**RESIDENTIAL PLAN CHECK  
 COMMENTS**

**PLAN CHECK NO:** 10172158

**PROJECT ADDRESS:** 717 E Third St

**PLAN CHECK ENGINEER:** Ahangian, Kathy **TEL: 714** 647-5812  
**FAX: 714** 647-5897

**ROOF PLAN**  
 SCALE: 1/8" = 1'-0"

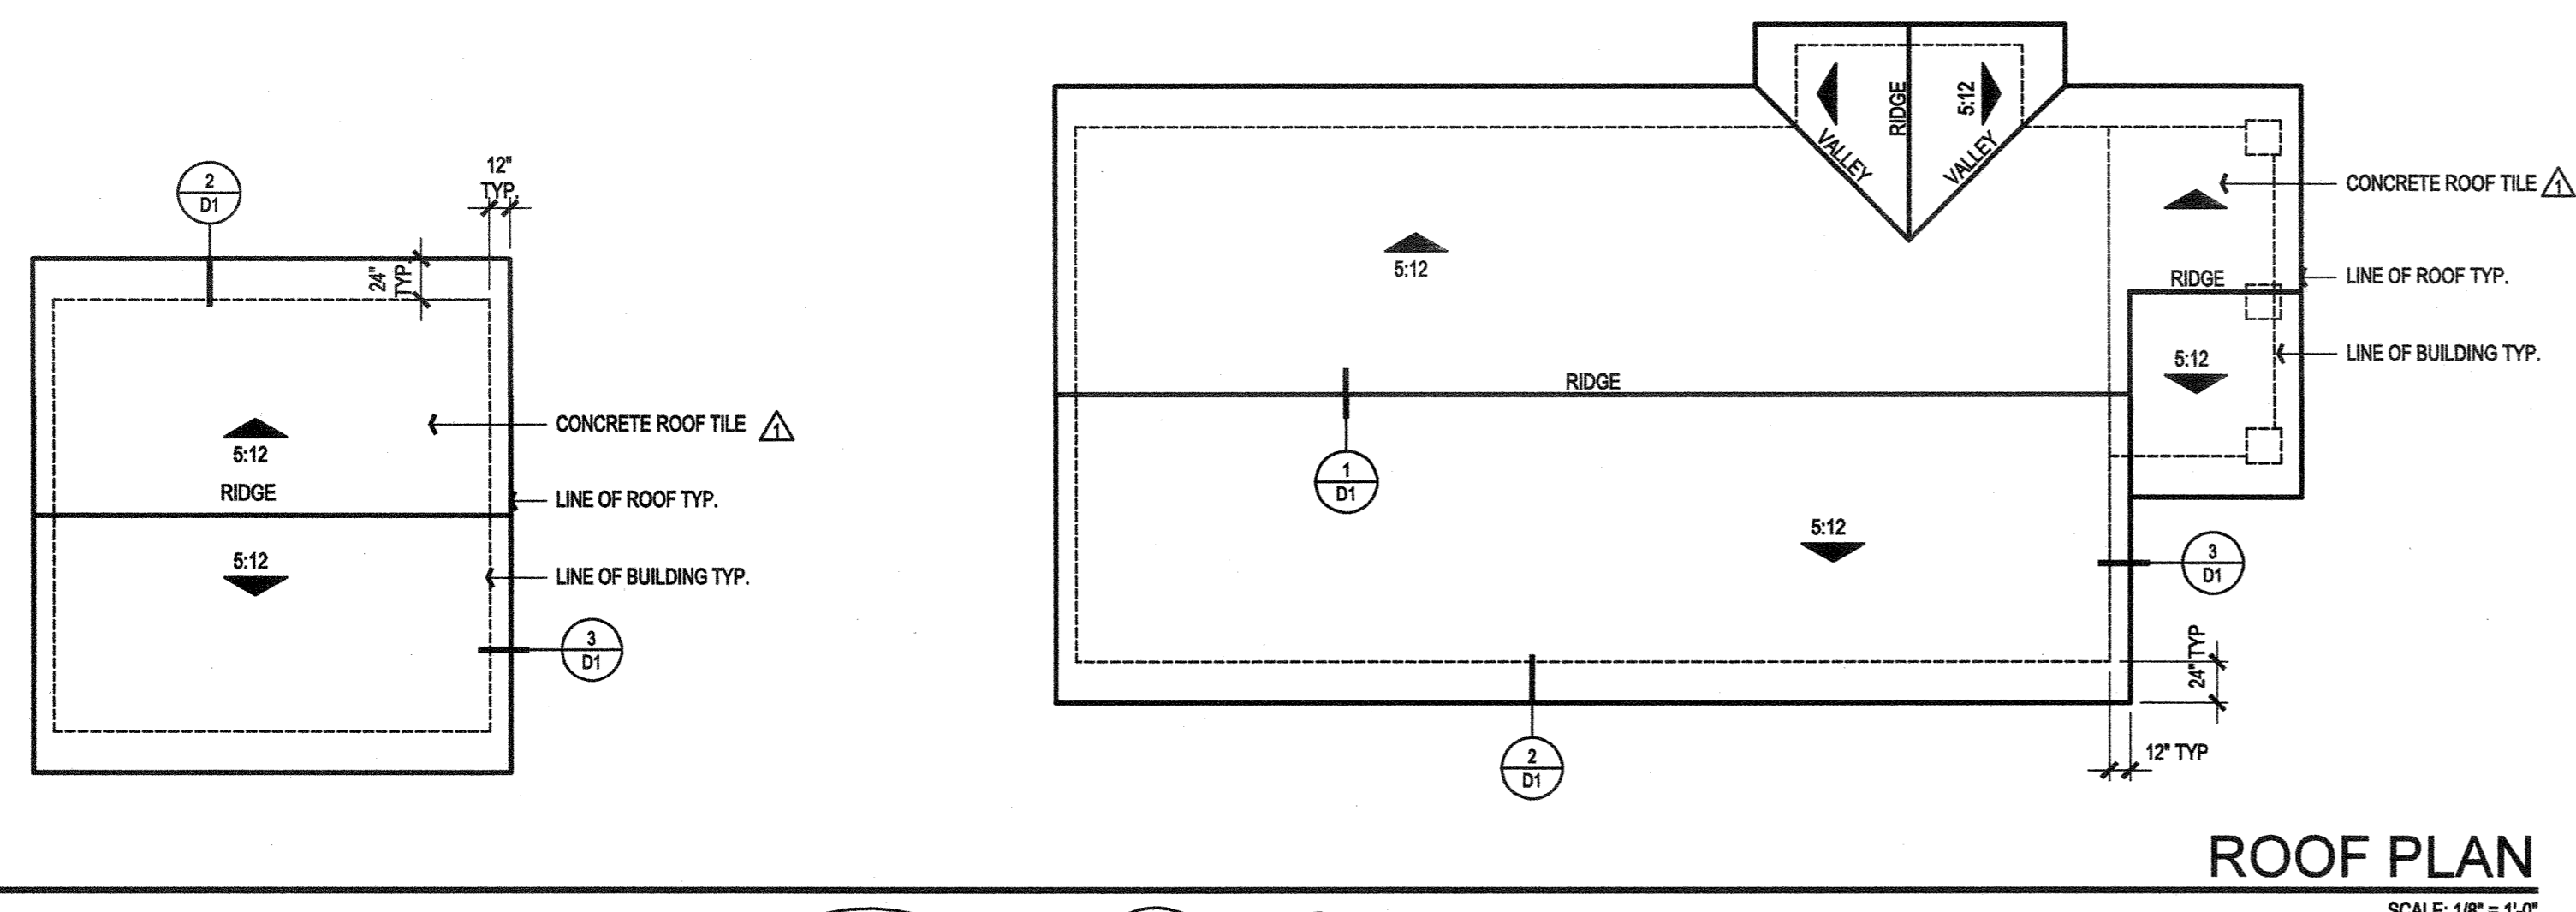
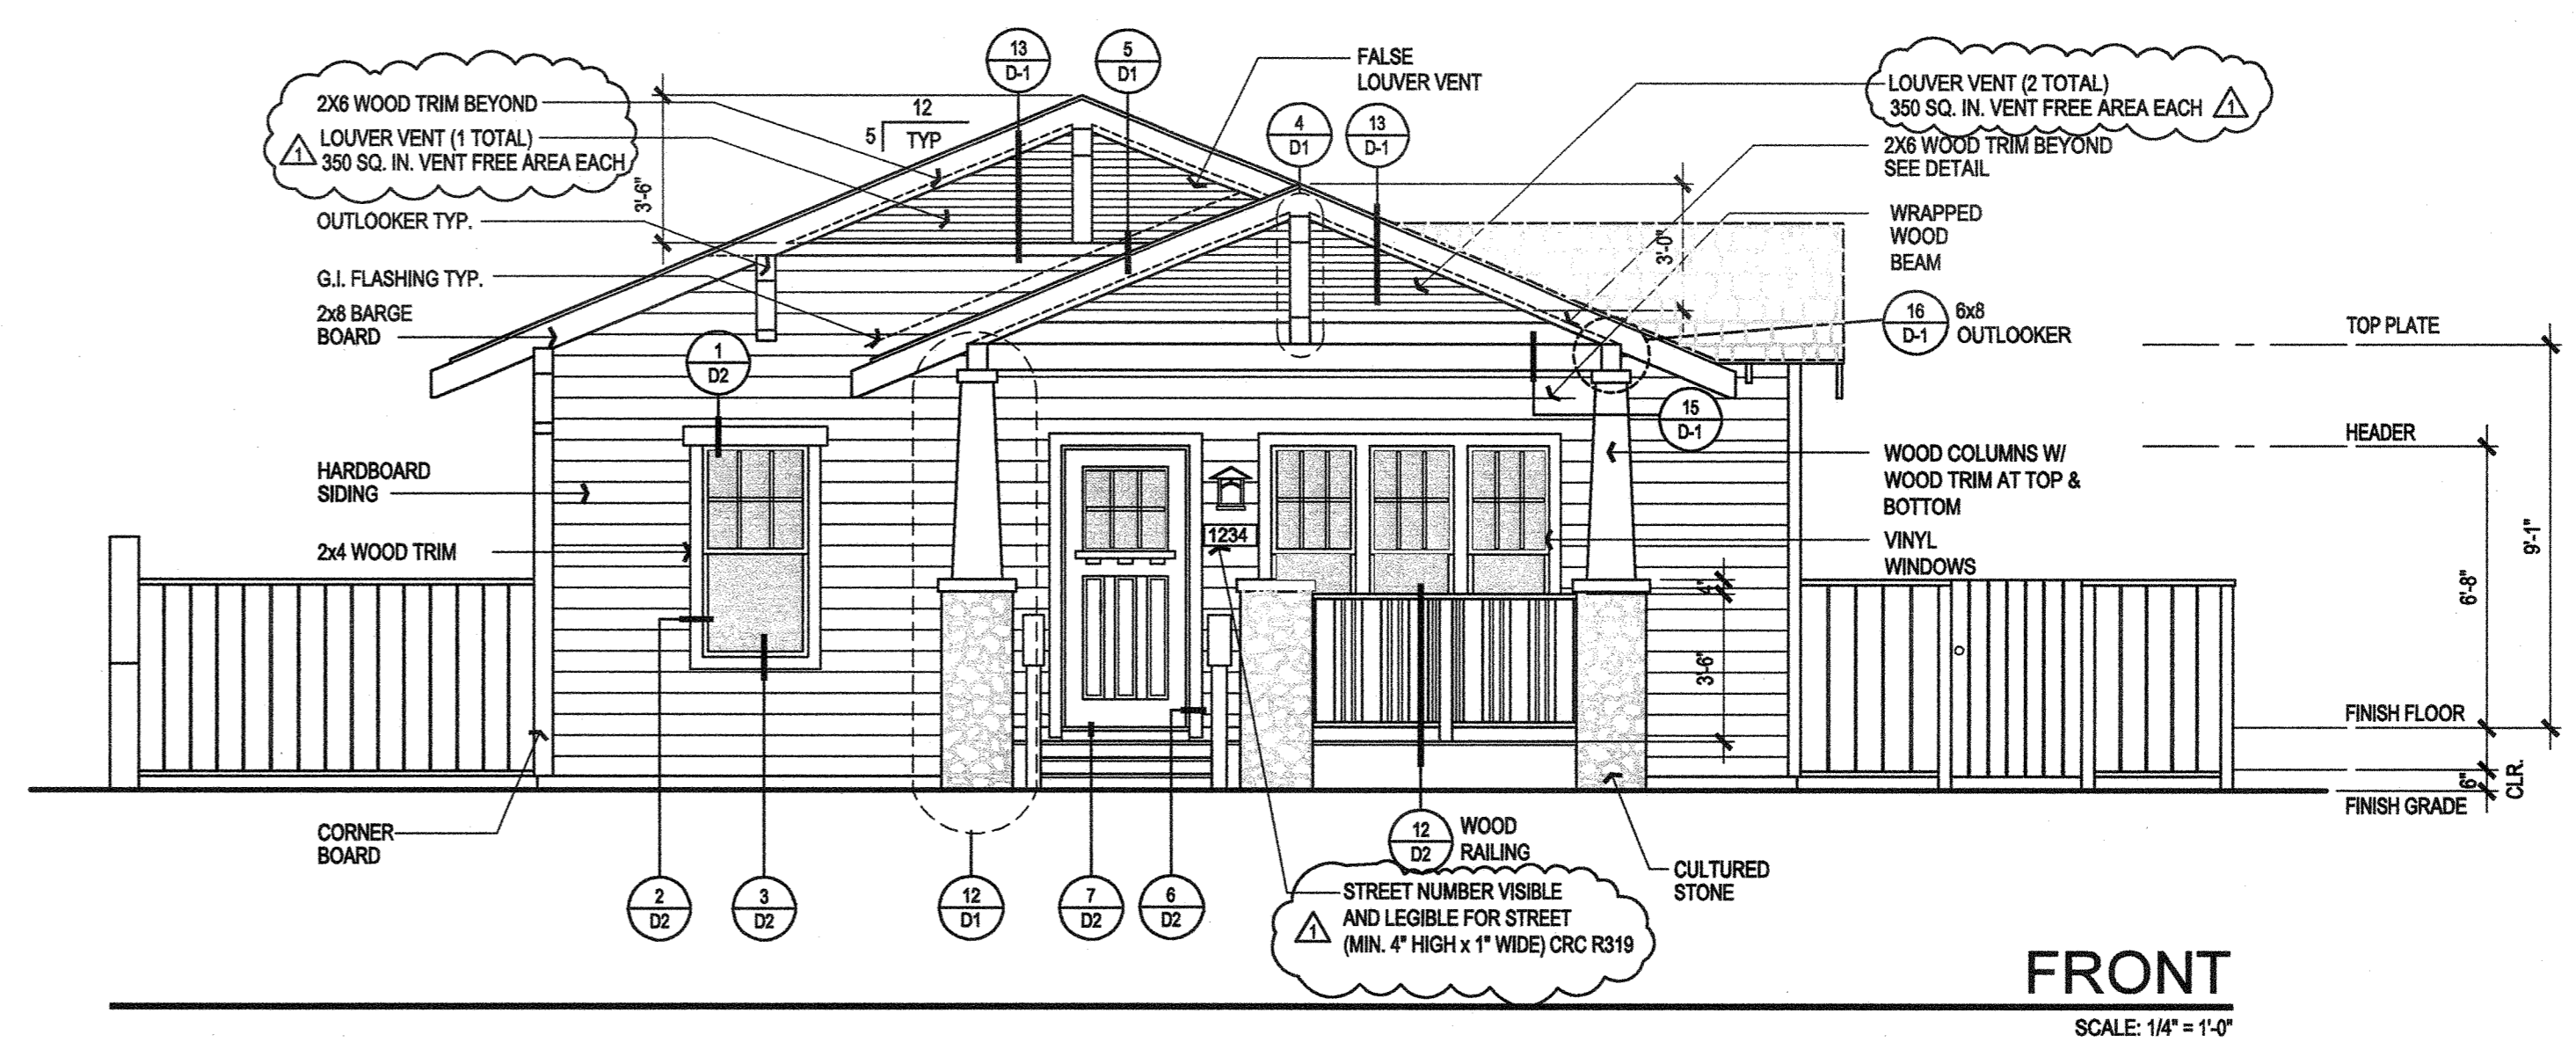
*10-21-11*  
15. Provide and show on the plans, house street number visible and legible from street. (Minimum 4"High x 1" Wide) CRC R319
